INTERIOR ALTERATION FOR 7 RESIDENTIAL UNITS, INCLUDING MEP WORK, IN EXISTING 3 STORY BRICK BUILDING WITH BASEMENT, 7 RESIDENTIAL UNITS (2 RESIDENTIAL DU COACH HOUSE NIC) AS PER PLANS AT: 2655 W HADDON AVE.

**TITLE SHEET
SITE PLAN & NOTES**
2655 W HADDON AVE
CHICAGO, IL 60622

CORRECTIONS TO PERMIT #100804598,
 INTERIOR ALTERATION FOR 7 RESIDENTIAL UNITS, INCLUDING MEP WORK,
 IN EXISTING 3 STORY BRICK BUILDING WITH BASEMENT, 7 RESIDENTIAL
 UNITS (2 RESIDENTIAL DU COACH HOUSE NIC) AS PER PLANS
 AT: 2655 W HADDON AVE.

CORRECTIONS AND RESPONSES:
 2655 W HADDON AVE.
 100804598

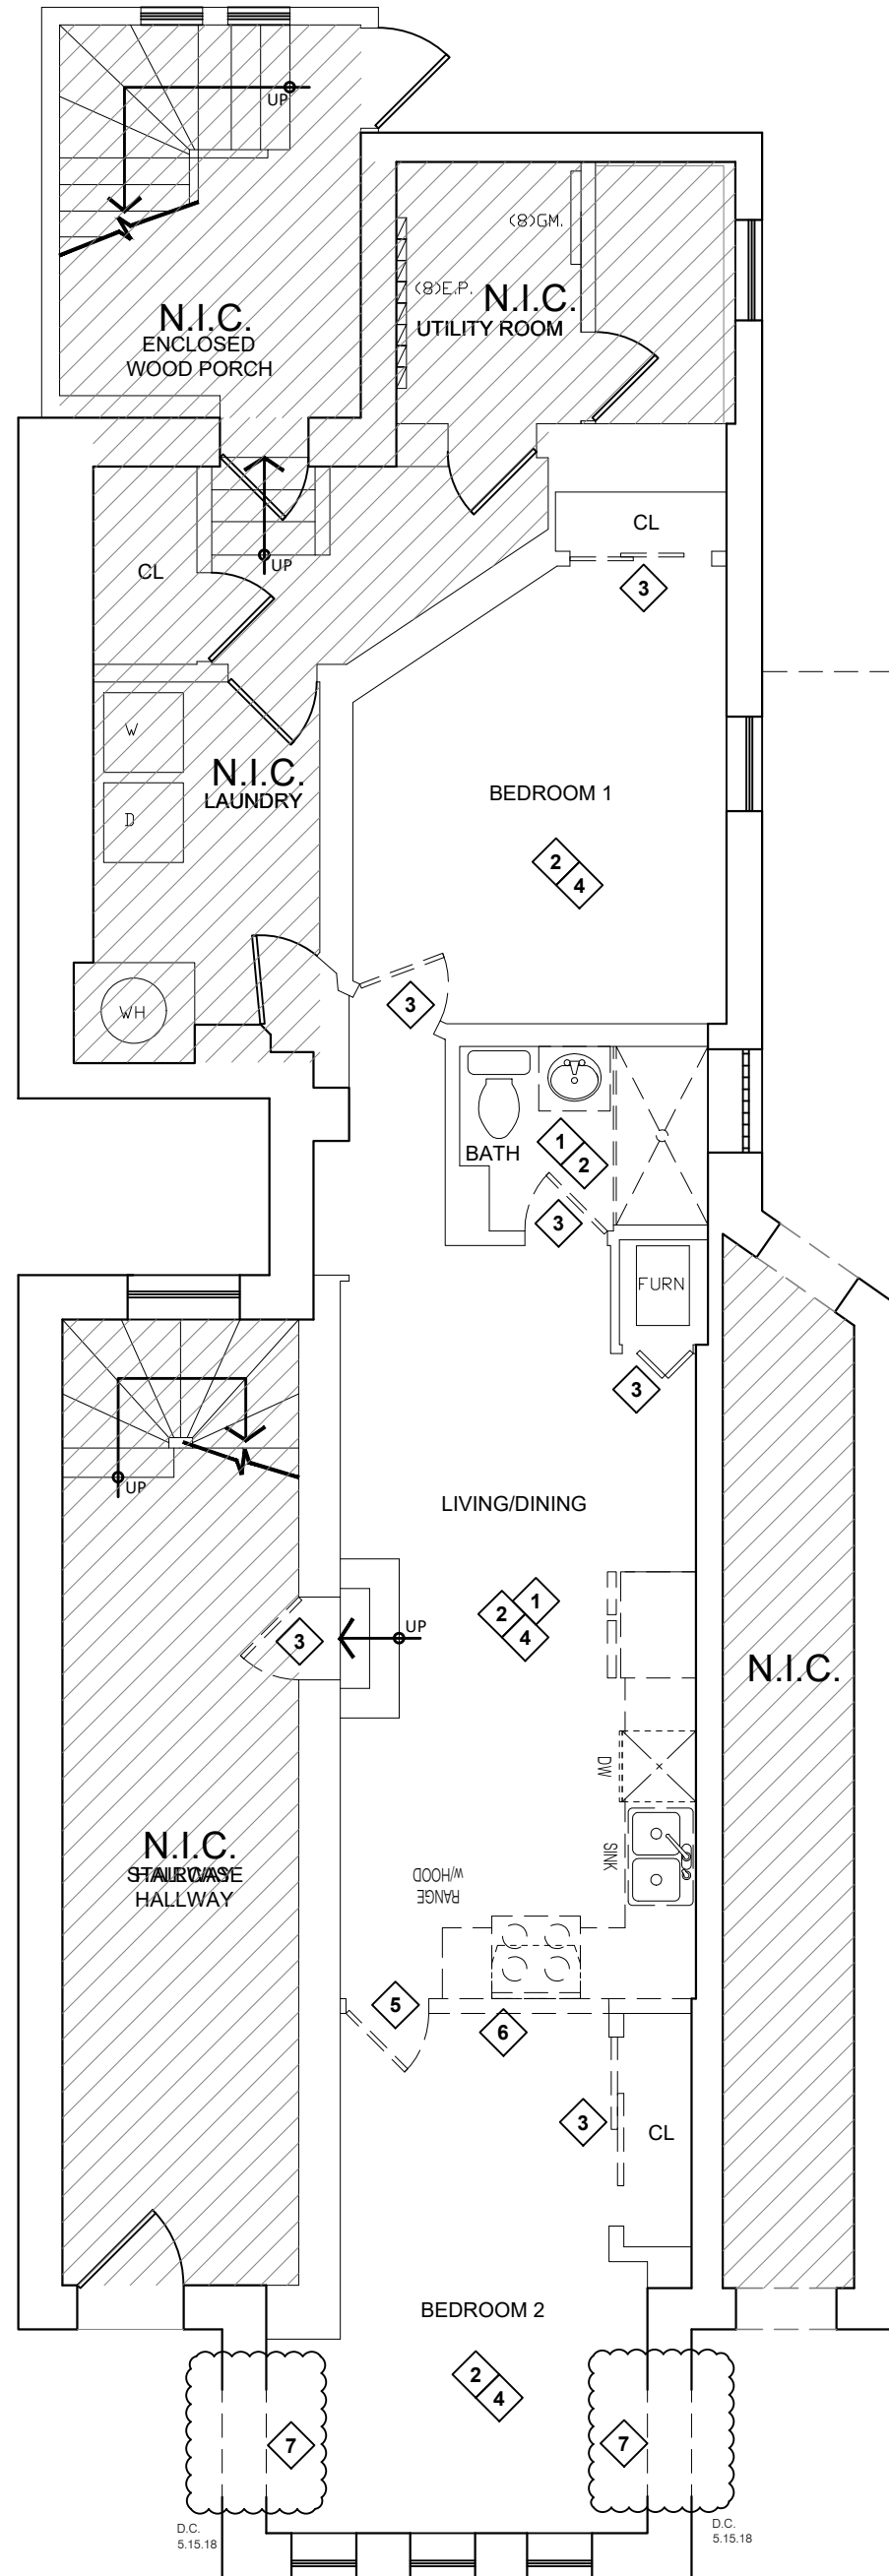
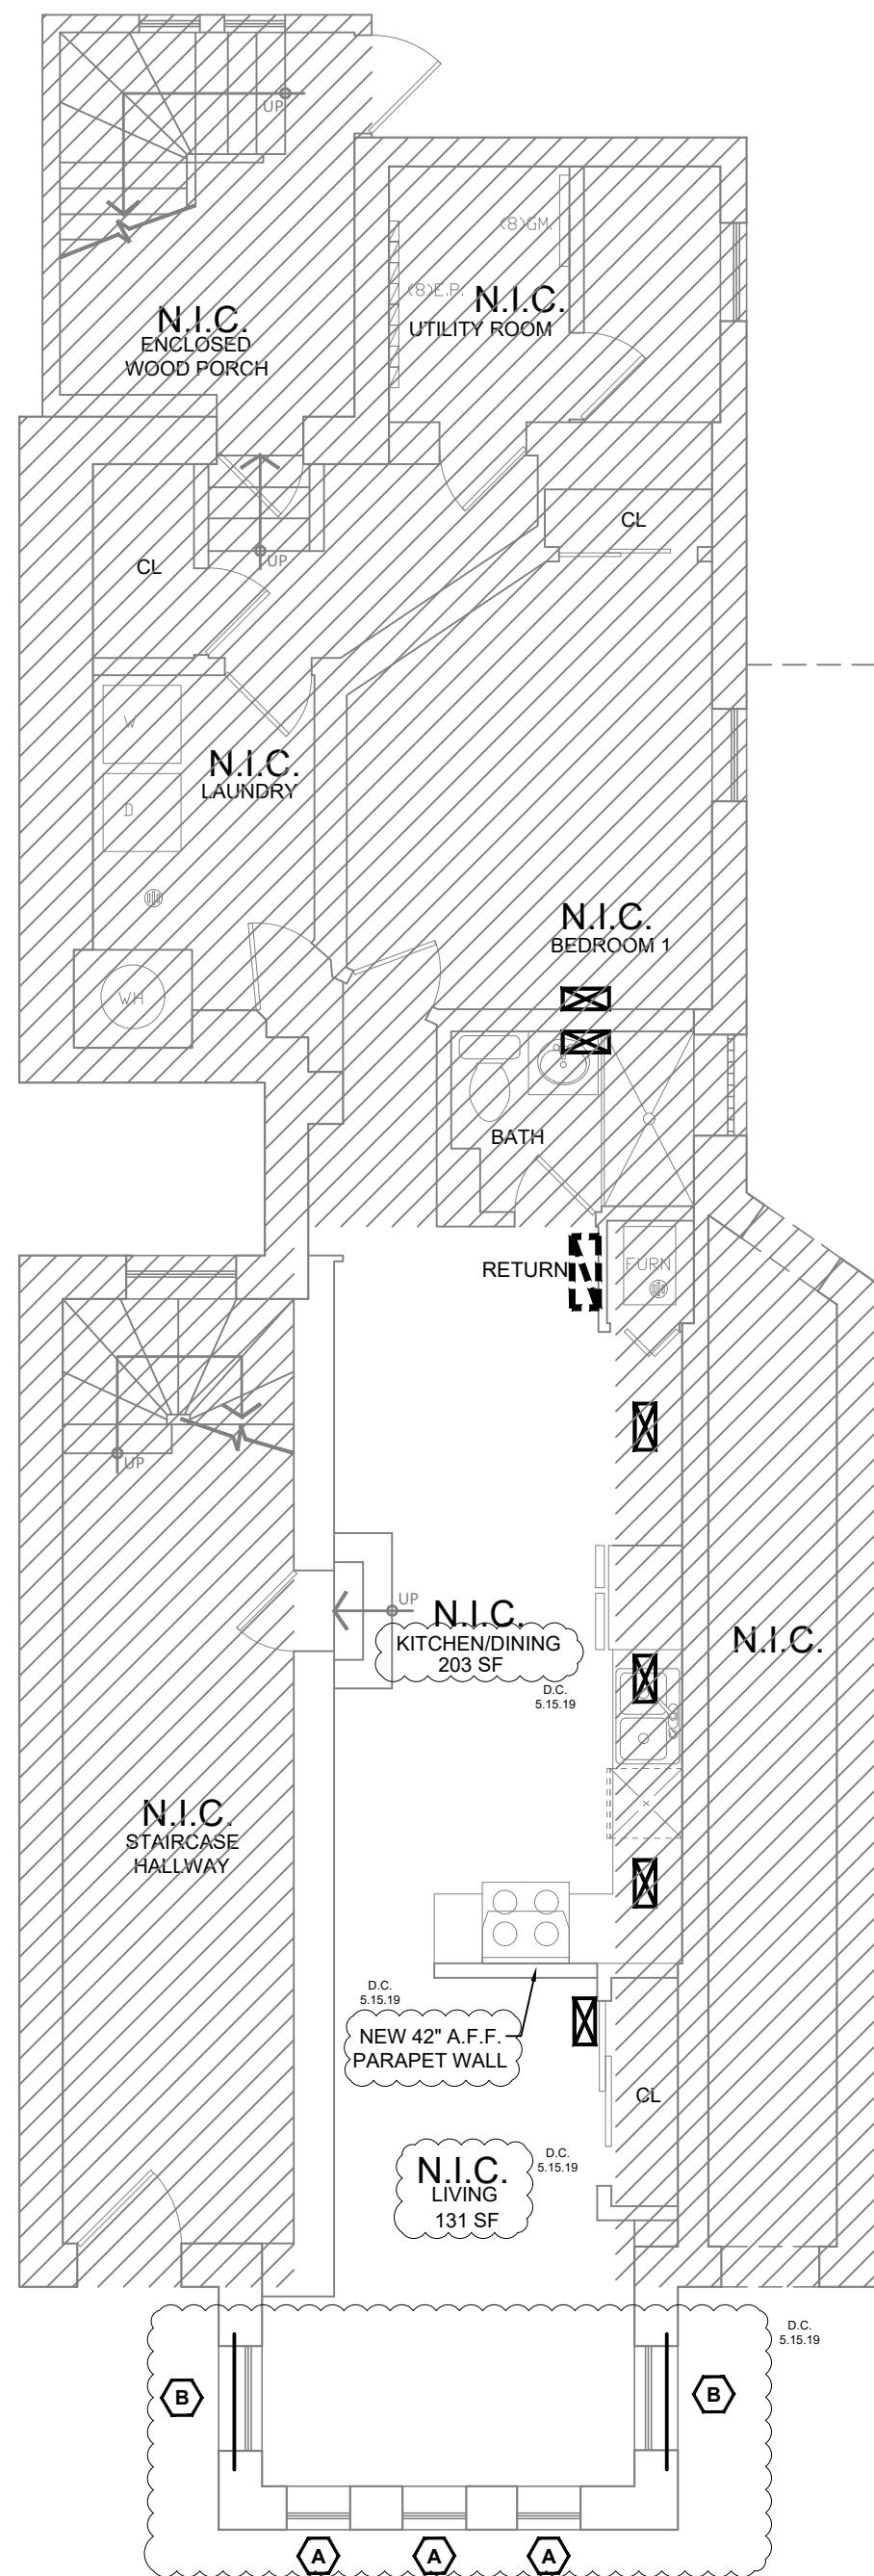
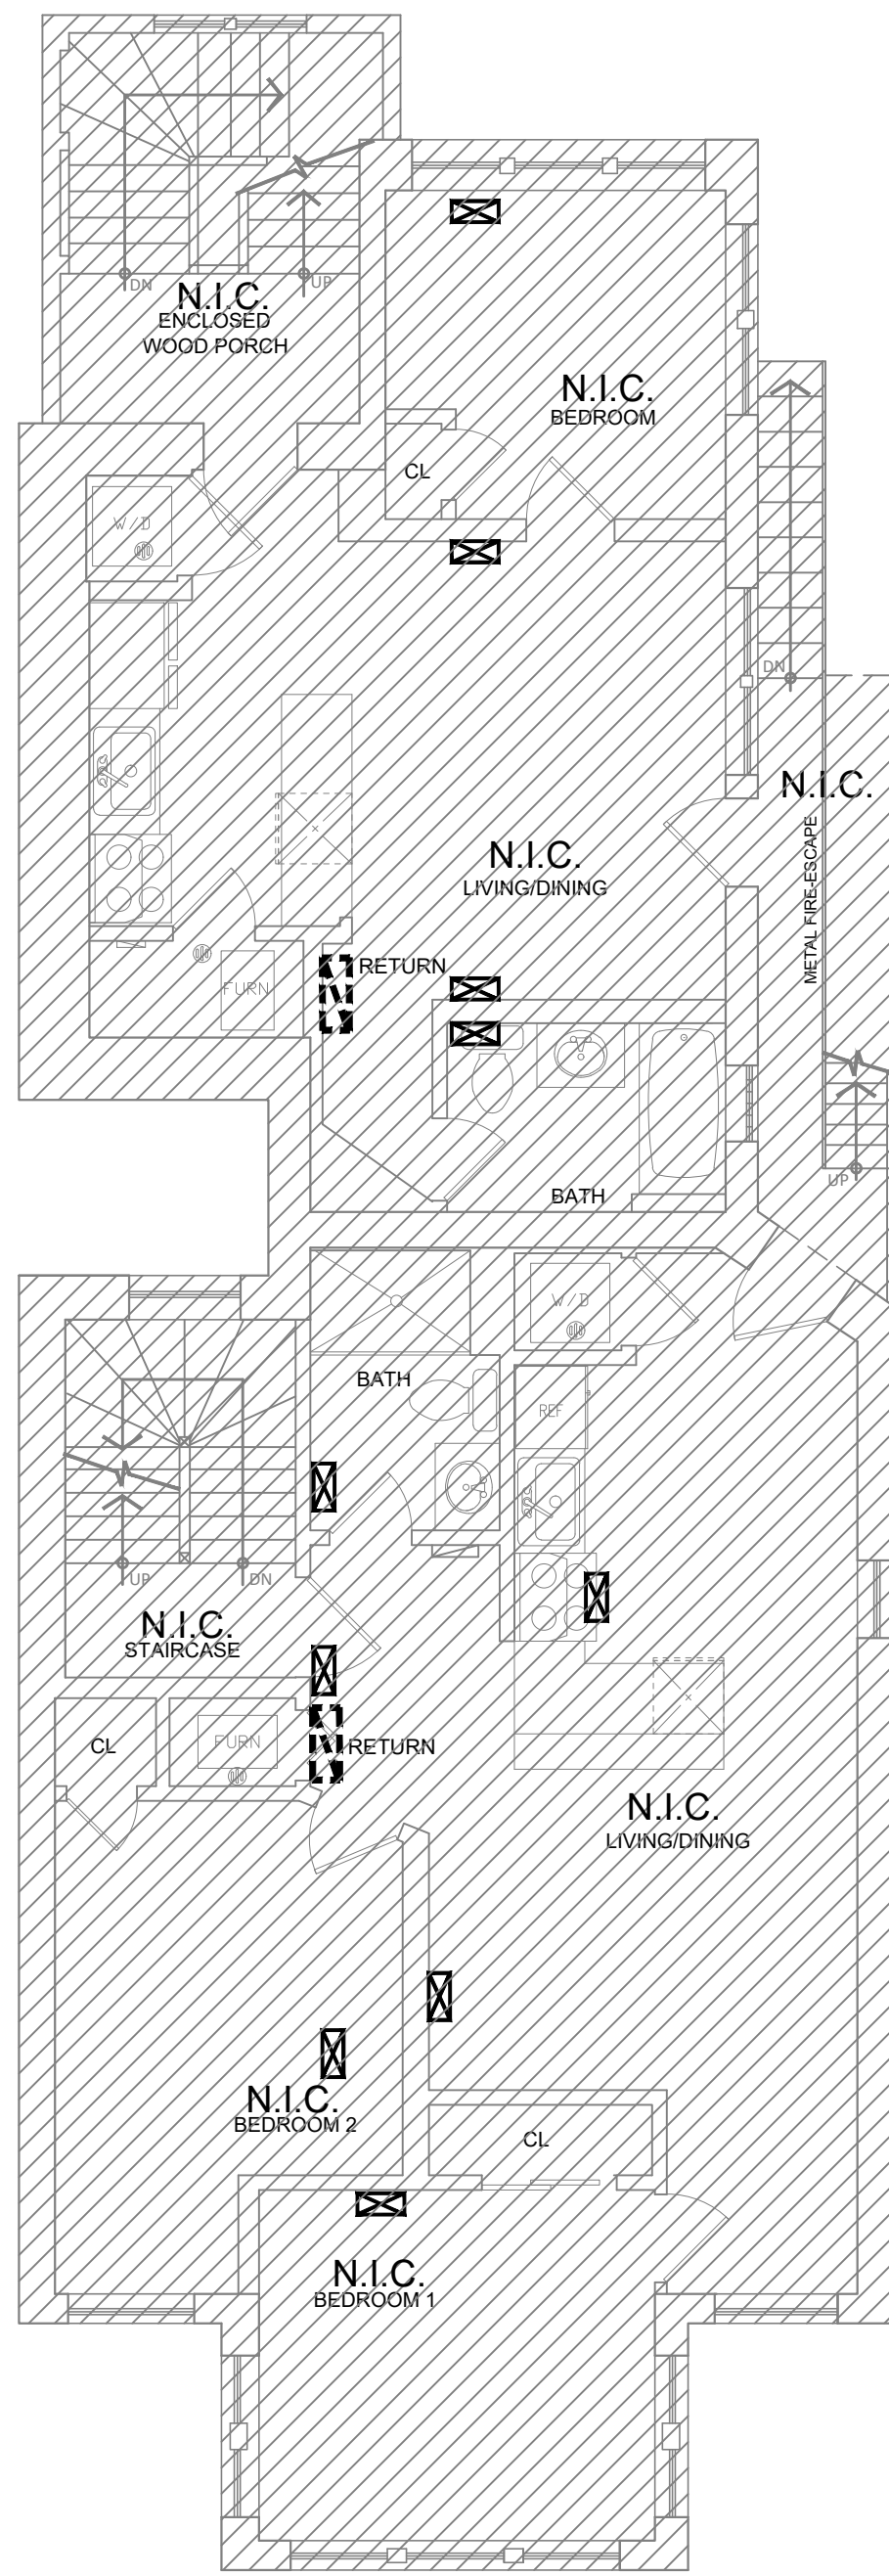
ARA0000 - ADMINISTRATIVE ISSUES. DINING AREAS REQUIRE NATURAL LIGHT AND VENTILATION.
RESPONSE: PLEASE SEE NEW WINDOWS FOR BASEMENT APARTMENT. EXISTING WALL TO BE REMOVED, NEW PARAPET WALL TO REMAIN. PLEASE SEE ARCHITECTURAL, DEMOLITION AND MECHANICAL PLANS FOR LAYOUT AND NEW WINDOWS WITH LIGHT AND VENTILATION SCHEDULES.
